CALIFORNIA COASTAL COMMISSION

STAFF RECOMMENDATION**ON CONSISTENCY DETERMINATION**

Consistency Determination No.: **CD-013-08**
Staff: **MPD-SF**
File Date: **3/20/08**
60th Day: **5/19/08**
75th Day: **6/3/08**
Commission Meeting: **5/9/08**

PROJECT DESCRIPTION: Western Range Instrumentation Modernization Program (Exhibit 3)

Figure 3: Modifications and new antennas proposed for Pillar Point.

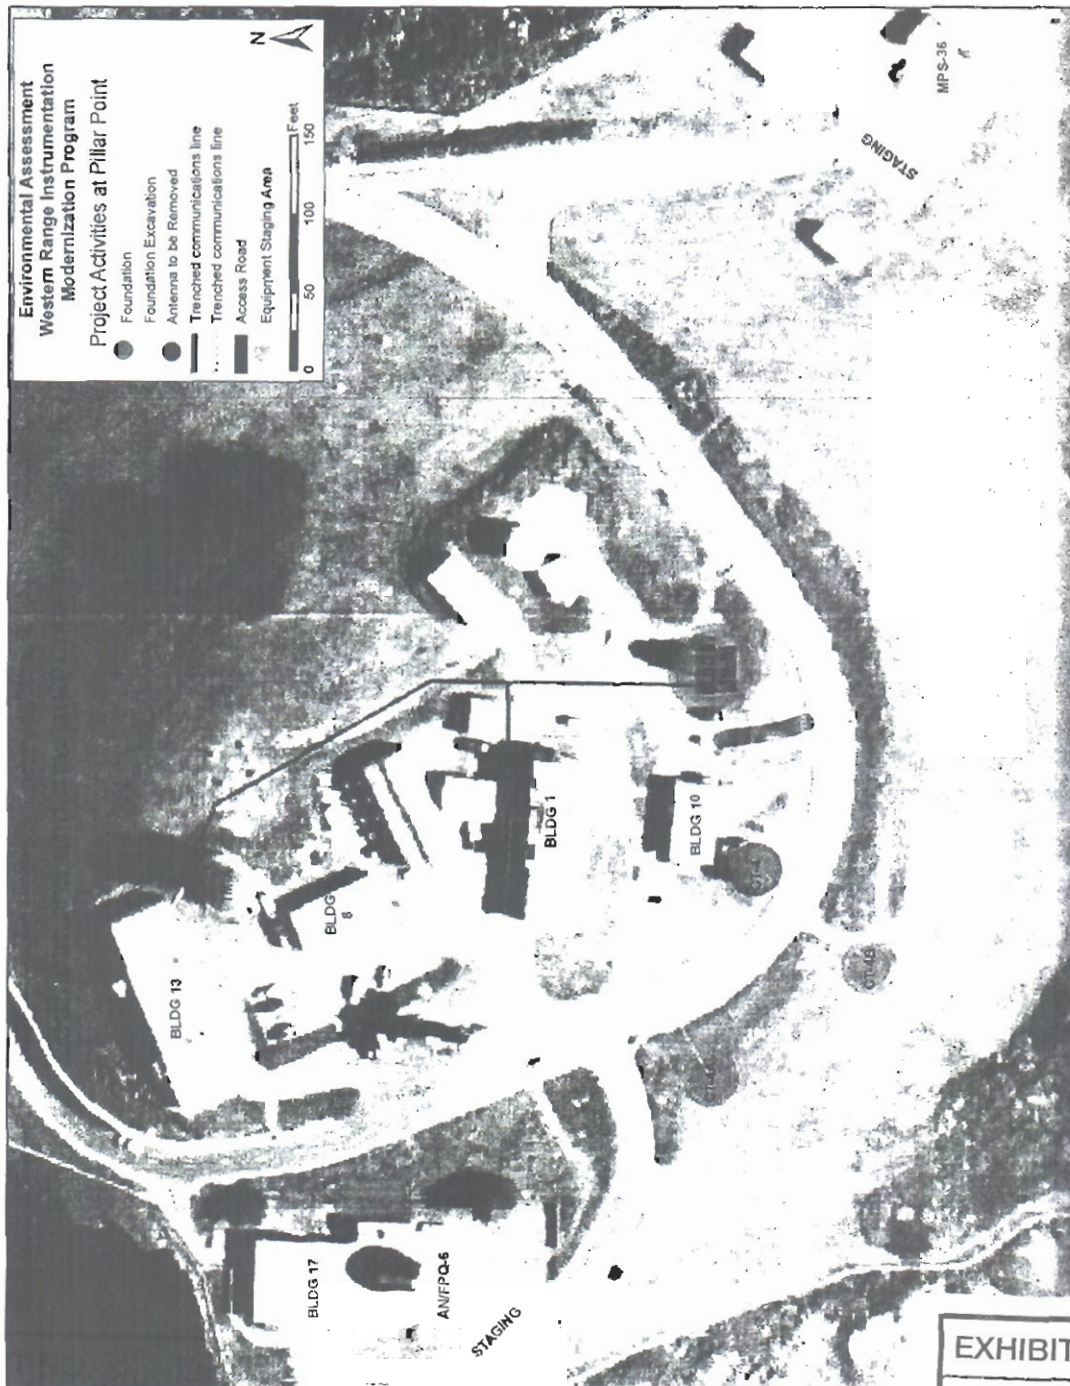
Commission staff request: How much flexibility, if any, does the Air Force have in siting the three new antennas at the site? Are there alternative configurations that could be further used to minimize the overall visual impact? What constraints dictate distances between the antennas, or distances from other buildings on the site? Could the two transmit ("CT-4") antennas, for example, be within the road and developed area, rather than outside it?

Air Force Response: The placement of the antennas is based on many factors, including physical space needs, proximity to control buildings, use of existing infrastructure, and phased use of currently operational systems and new systems. Placing the new the CT antennas outside the circle road and down the hill on the west side of the facility accomplishes several requirements. The CT placement ensures no interference or populated structures will be affected by the beam strength or operation azimuth (sweep). Moving the CT antennas inside the road / developed area would necessitate high towers for the beams to avoid existing buildings and equipment. Also,

CT placement on far side of the site allows use of natural rise at center of station to partially obscure the radomes used to protect the new CT antennas.

The TM-B location allows the older 40' telemetry antenna to remain in operation until the 44' TM-B is completed. The old 40' antenna must remain in operation until TM-B is up and operational (maintaining telemetry system redundancy at Pillar Point). TM-B will be on a shorter pedestal than TM-A, helping to reduce visual impact. TM-B is being placed inside the circle road at a previously disturbed site (Bldg 9 site).

Simulated View from North

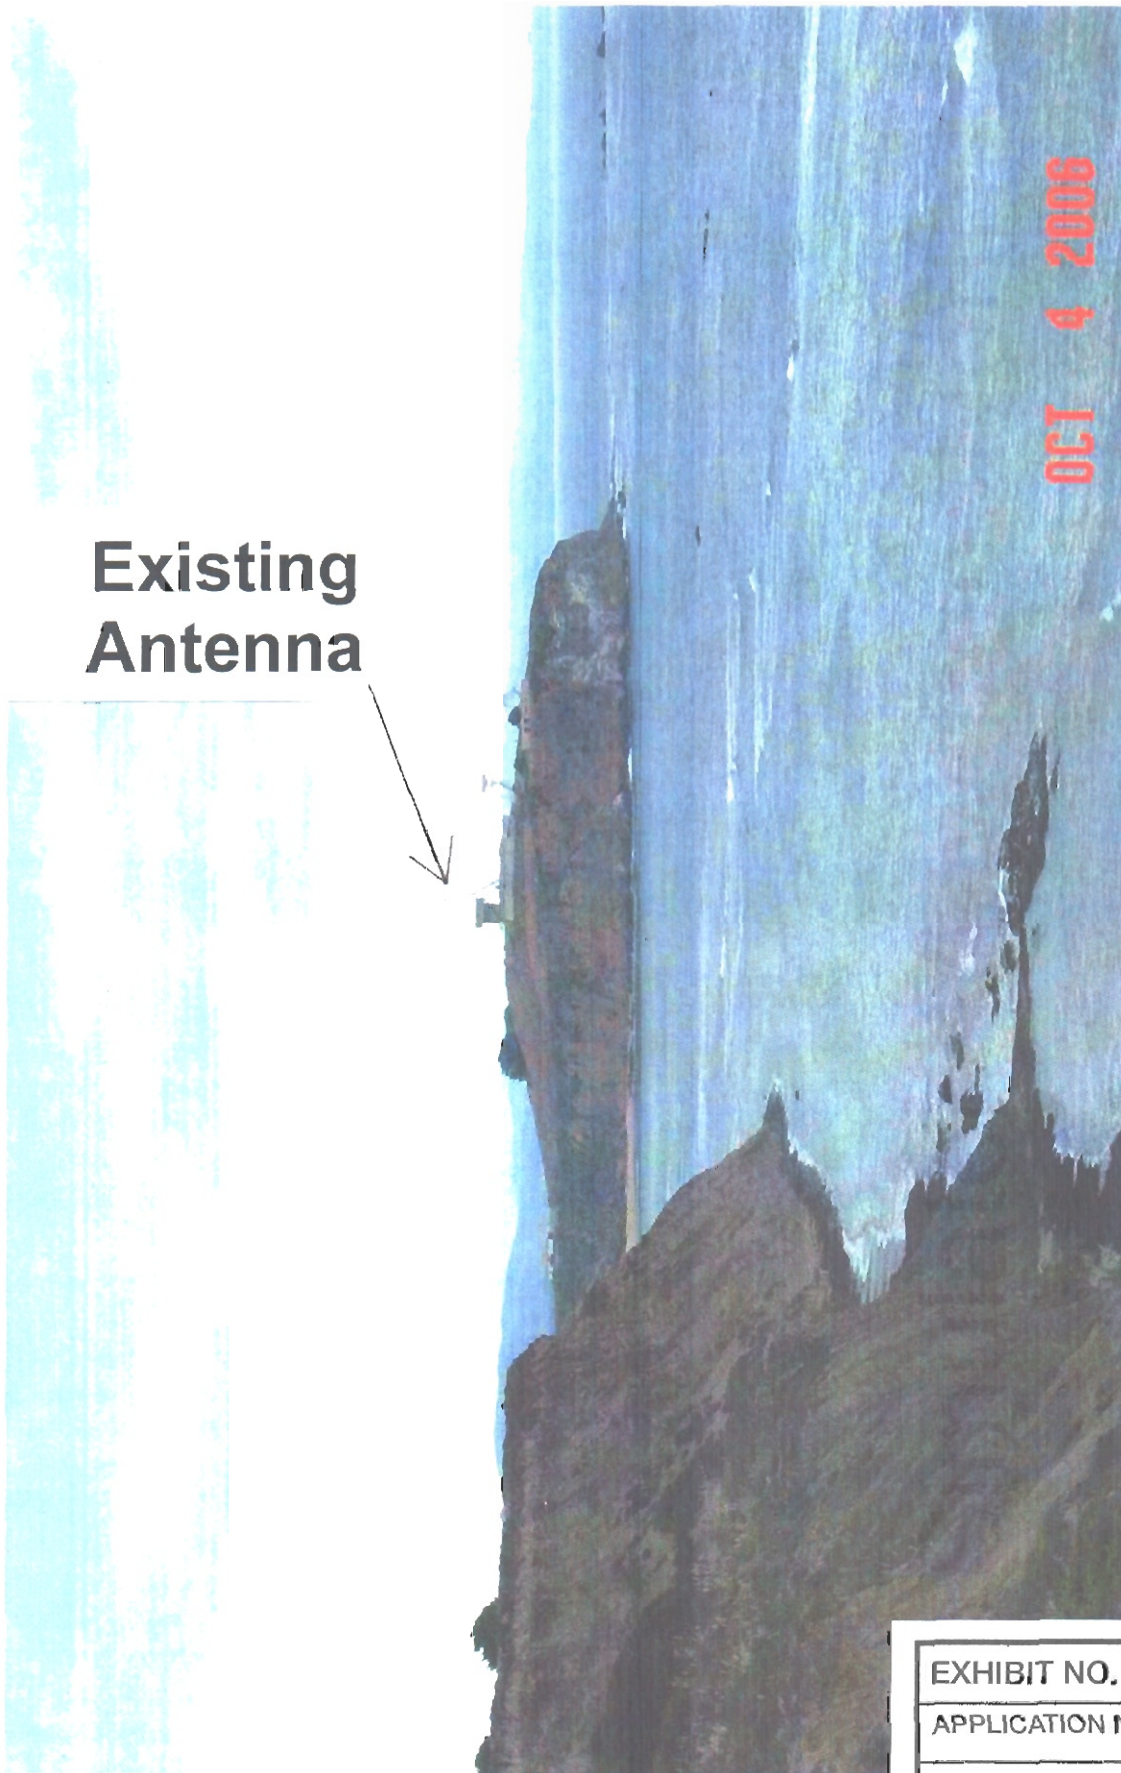
In reviewing the Air Force's previously-proposed, and now installed, antenna/radome on the site (CD-089-06), the Commission noted it was highly visible and by far the tallest Air Force structure on the site, and that it sits on almost the highest topographical point at the site (Exhibits 5 & 6). The three proposed new antennae/radomes would not be as high, because they are all shorter and set at lower elevations. The Air Force states:

Nevertheless, due to the site's prominence from views in all directions, the structures would be highly visible and they would result in the proliferation of additional unnatural-looking structures in a highly scenic viewshed. Thus, they raise similar view protection issues to those raised in CD-089-06. In other words, they raise the need for a through alternatives analysis to determine whether visual impacts can be minimized or eliminated, and consideration of mitigation measures.

Figure 5: Aerial line drawing of the tree plantings in relationship to the PPAFS structures.

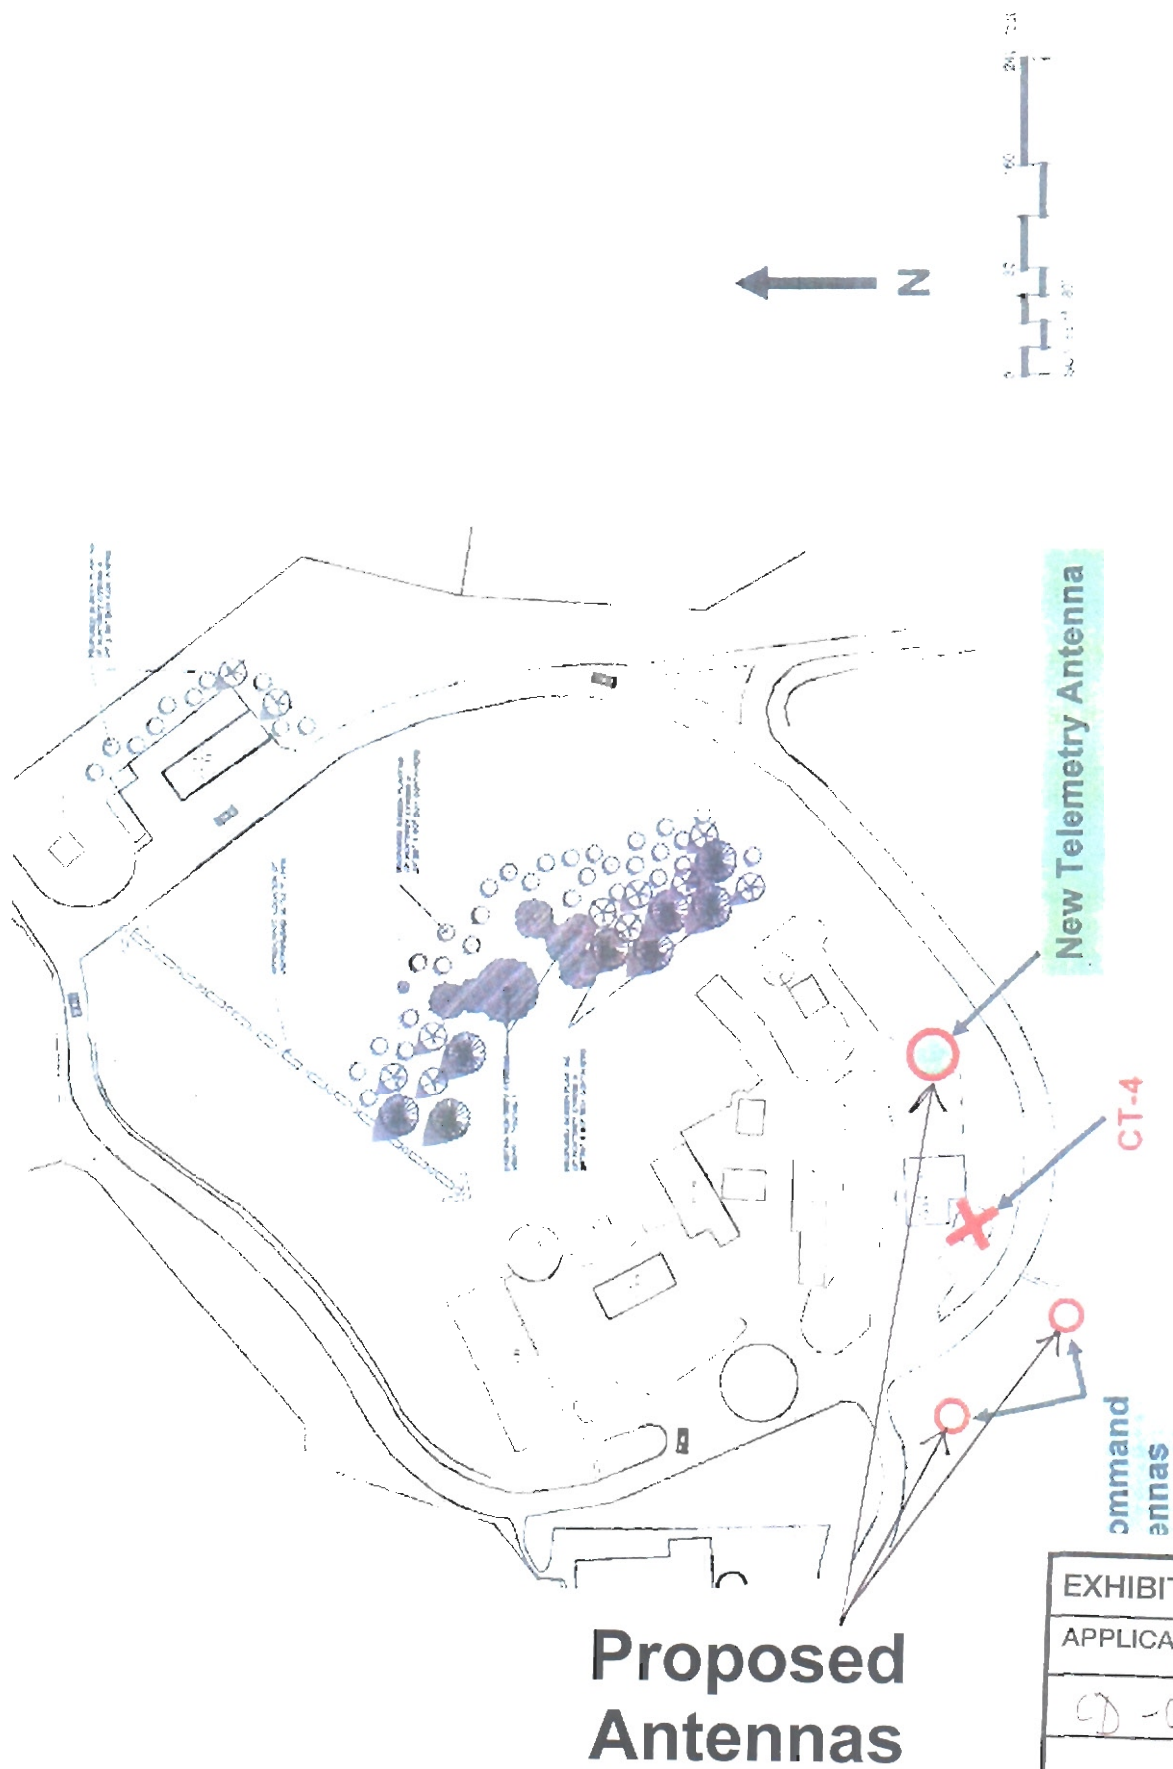
Commission staff request: As noted above, the Air Force is planting vegetative screening for the previous radome we concurred with. Are there opportunities for additional screening? Are there other measures the Air Force could undertake to improve public views in the area?

(1) When the Air Force set out to design landscaping at PPAFS as a condition of CD-089-06, we first reviewed the existing plant types at the site and nearby locations to determine an appropriate palette of planting that would adapt to the local climate. Given that a small grove of Monterey cypress trees currently exists at the site, we decided to expand upon those trees using the same species. Once mature, the height of the cypress trees would create the desired visual improvements for softening and screening the built structures. We then analyzed the public view corridors around PPAFS to determine the optimum locations for planting the trees. From this analysis, we developed a landscaping perimeter. The landscaping perimeter was then evaluated for obstacles, including radar and telemetry line-of-site interference, topography, and existing buried infrastructure (e.g. com, electrical and water lines). Once all these factors were considered, the final landscaping perimeter was designed to create the maximum feasible extent of visual coverage.

The landscaping perimeter was then evaluated for obstacles, including radar and telemetry line-of-site interference, topography, and existing buried infrastructure (e.g. com, electrical and water lines). Once all these factors were considered, the final landscaping perimeter was designed to create the maximum feasible extent of visual coverage.
